DEVELOPMENT REVIEW COMMITTEE (DRC) **COMMENT REPORT**

Flagler SV **PROJECT NAME:**

CASE NUMBER: UDP-S22020

Site Plan Level II Review: 270 Multifamily Residential Units and 2,680 Square-Feet of Commercial Use in the REQUEST:

Principles of Building Design

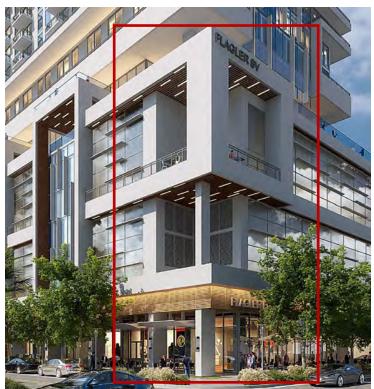
- a. B2, B15, The second-floor corner element at the intersection of NE 5th Avenue and NE 4th Street should be enhanced to create more of a focal point. Consider utilizing this space for public access/seating with a balcony as created on the fifth floor. As shown in renderings, the mechanical vents for the garage are shown on this corner but are not shown in elevations. Confirm if vents are to be located at this corner or could be relocated to enhance this corner element.

- b. B7, In locations where towers are located on streets that are less than 60-feet wide, increased stepbacks from the "shoulder" are encouraged at 30-feet to reduce the impact on the street. Both NE 5th Avenue and NE 4th Street are less than 60-feet wide and the tower stepback is proposed at 15-feet for each elevation. Additionally, while the tower meets the 15-foot stepback requirement from the podium façade, proposed balconies and architectural elements extend a total of 8-feet into the required stepback. Due to the encroachment of balconies and architectural elements into this area, the stepback is further reduced and does not meet the intent of this principle. Per the ULDR,

c. B11, While there are active uses located on the ground floor, consideration should be given to provide an entrance at the corner of the commercial space.
